**CITY OF AUSTIN –DEVELOPMENT SERVICES DEPARTMENT
SUBDIVISION APPLICATION – MASTER COMMENT REPORT**

CASE NUMBER: C8-2022-0330
UPDATE: U0
CASE MANAGER: Juan Enriquez, Senior Planner juan.enriquez@austintexas.gov

PROJECT NAME: Harris Branch Commerce Park(W/R C8-2020-0186)
LOCATION: 6400 E PARMER LN

SUBMITTAL DATE: January 23, 2023
FINAL REPORT DATE: February 16, 2023

HARRIS BRANCH COMMERCE PARK
ONSITE FLOODPLAIN - SW CHANNEL

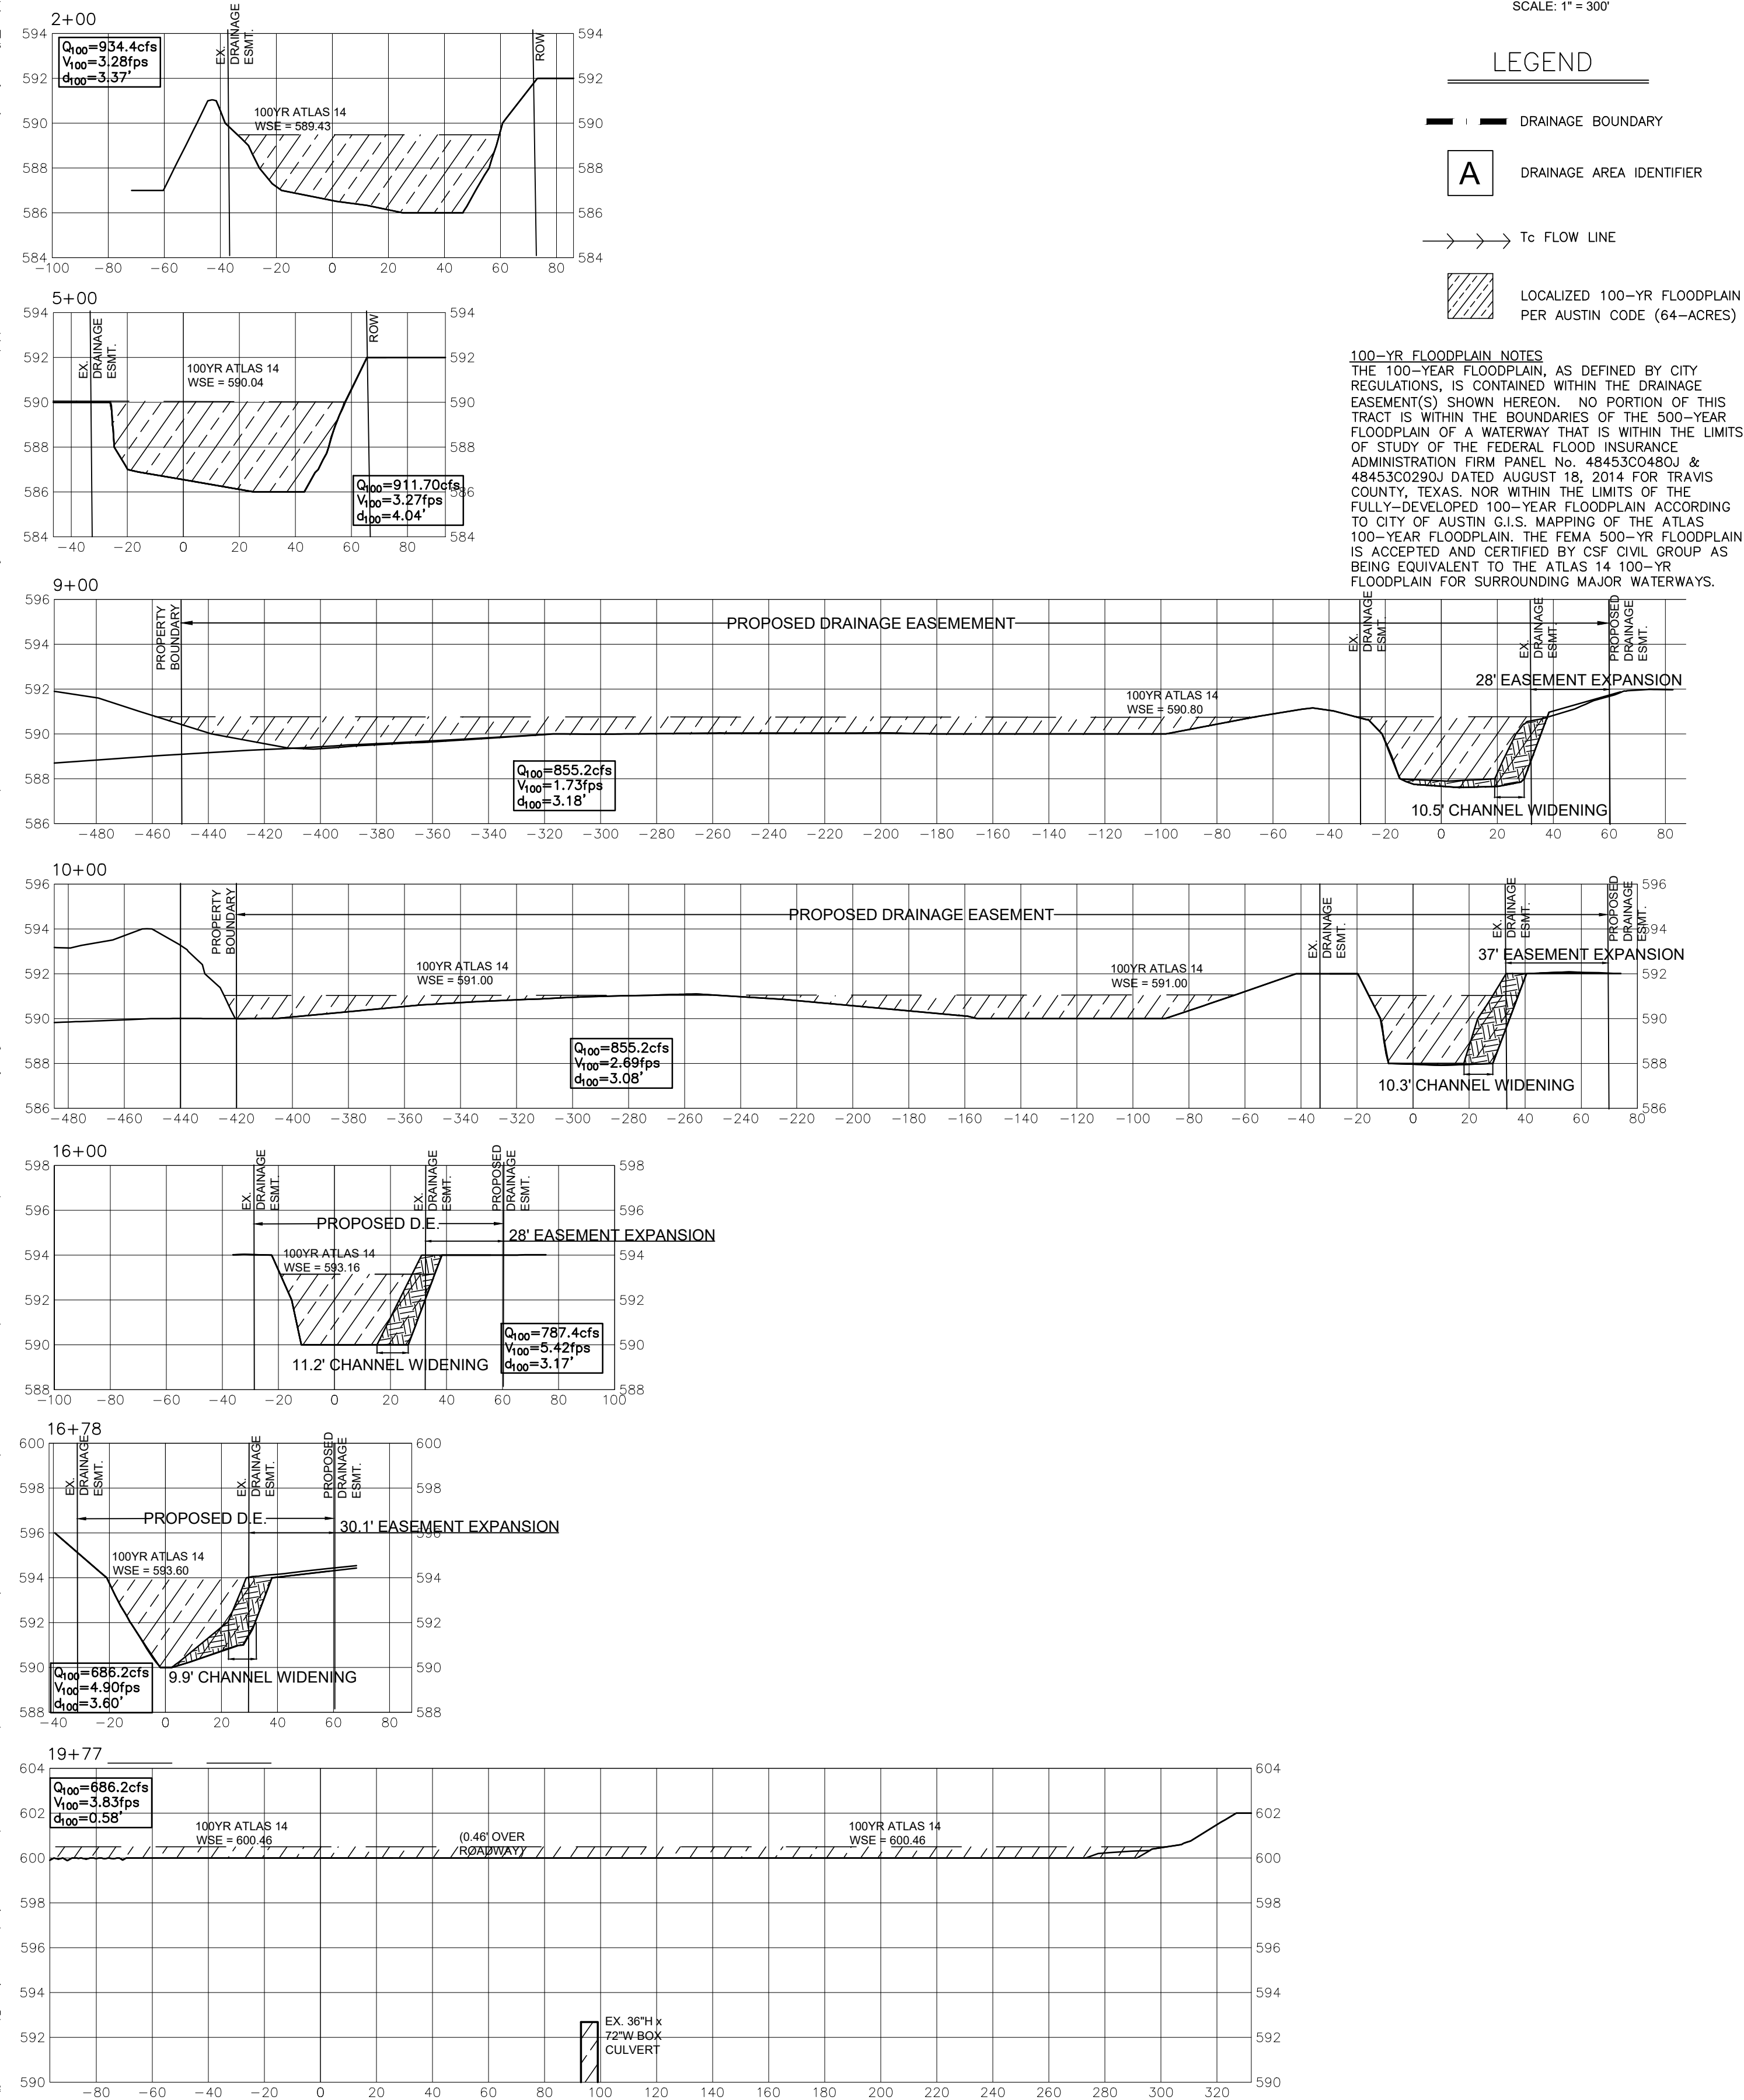
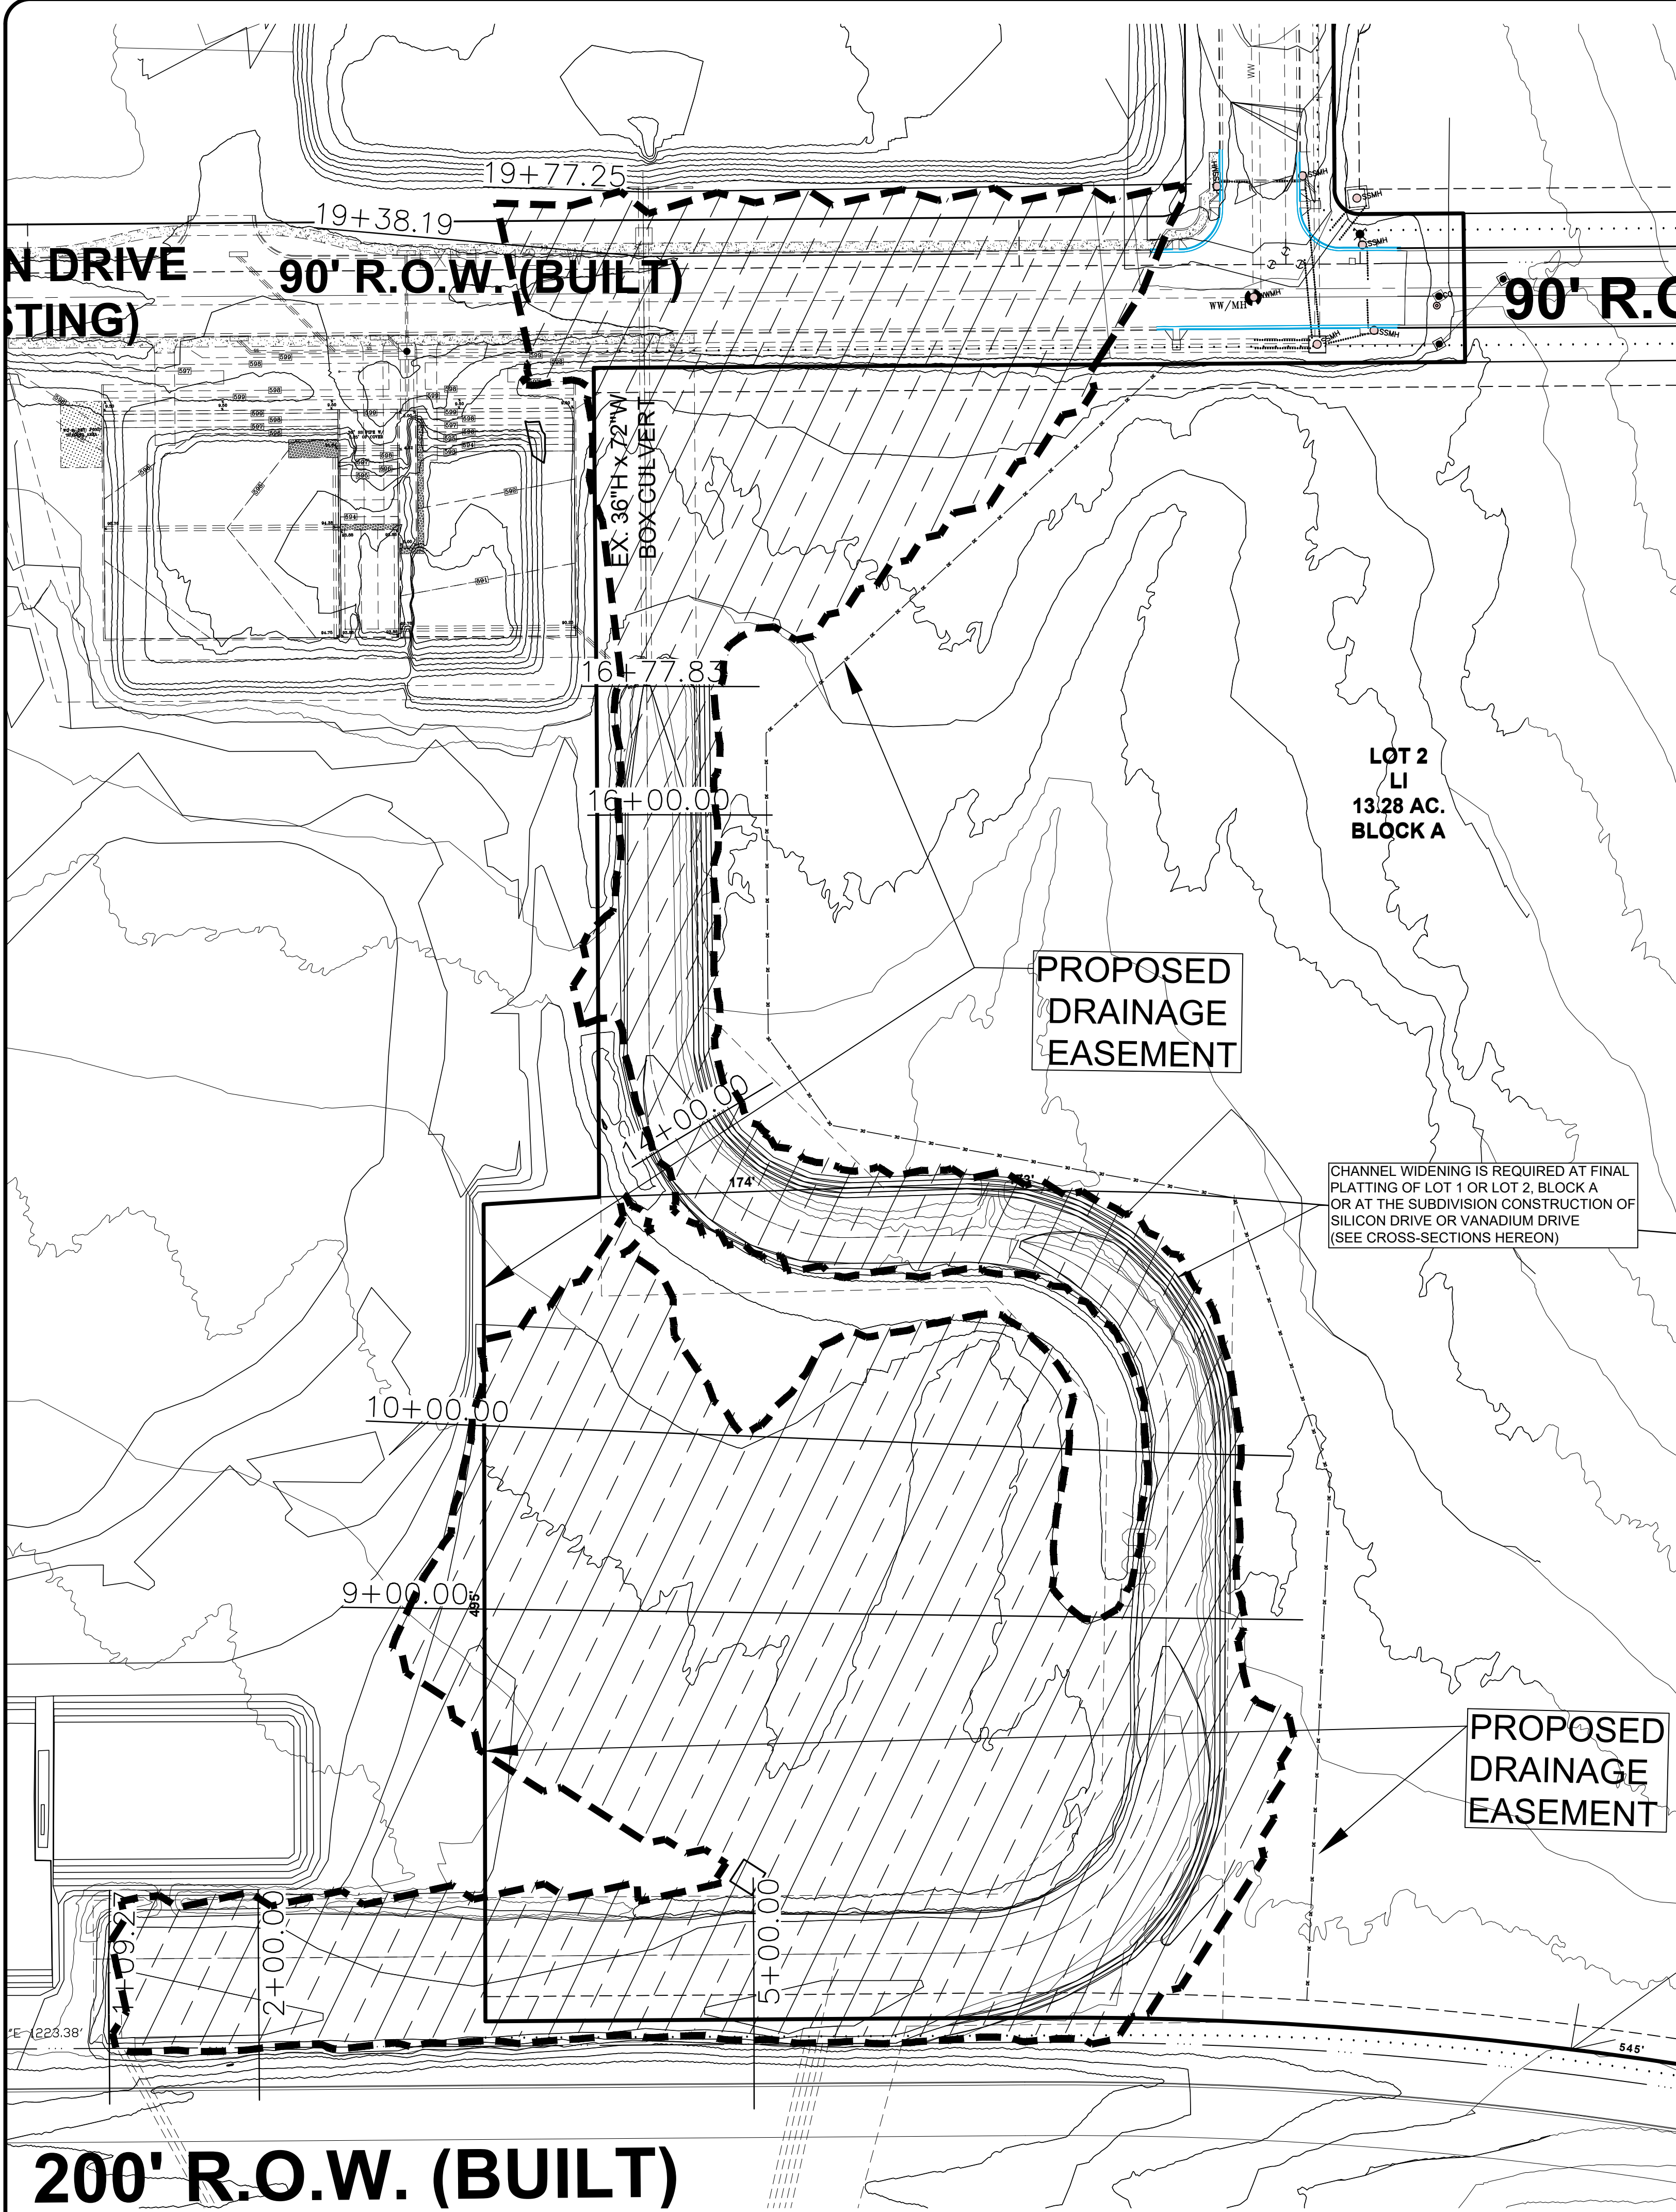
- FP3: Confirm that no modifications are proposed at subdivision construction phase for either tributary on the lot. **U0: No modifications are proposed at construction stage, the engineer states that channel widening is proposed with a later site development permit. It is unclear if the modeling is showing existing or proposed geometry conditions. Engineer will be required to show existing conditions floodplain and contain the existing 100-year floodplain to a drainage easement. Based on the comment responses and how the plans are shown, it appears that proposed conditions are being modeled and delineated. If channel modifications are changed to be completed during the subdivision construction plans, show both the existing and proposed RAS models with their respective existing and proposed geometries. The same flow files should be used. Once the proposed floodplain is reviewed and approved to ensure no adverse impact, the proposed drainage easement may contain the proposed floodplain. At construction plan formal review, the floodplain reviewer will ensure that the channel modifications are proposed and are shown as the same as what was submitted for the preliminary plan.**

- FP6: Provide a more concise hydraulic workmap for both tributaries. The workmap should include the 100-year ATLAS 14 floodplain, contours, contour values, drainage/proposed drainage easements, Cross sections, and WSEL's at each cross section within the floodplain report. **U0: Comment cleared.**

- FP7: Include a cross section just upstream of the culvert on the lot for the southern tributary with a contraction/expansion coefficient of .3/.5 respectively. Include the culvert in the RAS modeling as well. **U0: Culvert added at silicon drive, however there has been no culvert added at the downstream end of the site under Parmer Lane. The existing culvert under Parmer Lane for this tributary needs to be modeled, and a cross section just upstream and downstream of the culvert should be added as well with a contraction/expansion coefficient of .3/.5 respectively. See screenshot below of culverts that should be added. The private culverts can be seen in pink.**
